Product Change Notice

June 2020

Models: TL-2450/P with disc; Catalogue No. 11 1 13763 02 and
TLH-2450/P with disc; Catalogue No. 11 1 15763 02.

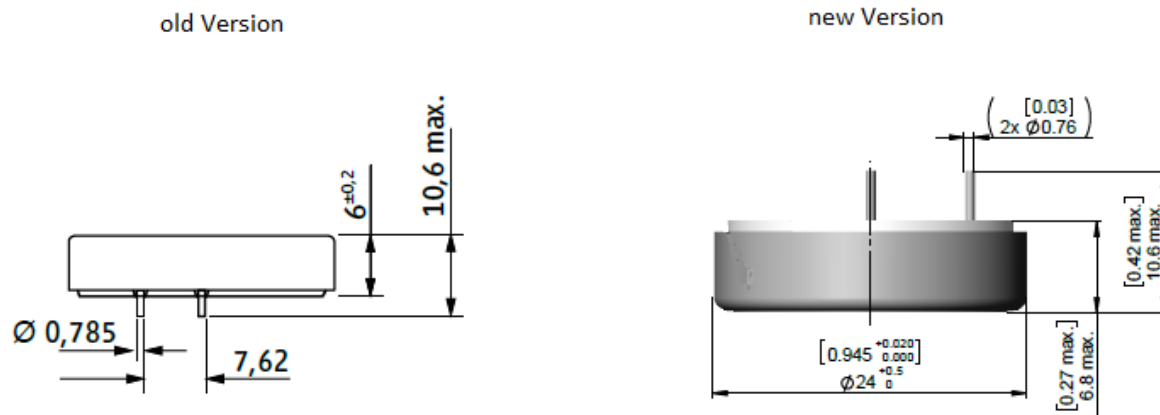
Tadiran Batteries has decided to change the insulation disc of TL(H)-2450. This will affect the whole model range of the product and will be put into production from the second half-year 2020 onwards.

The new insulation disc is up to 0.8mm thicker. This also effects the available length of the pins by 0.8mm.

The appearance could either be with or without visible extraction points
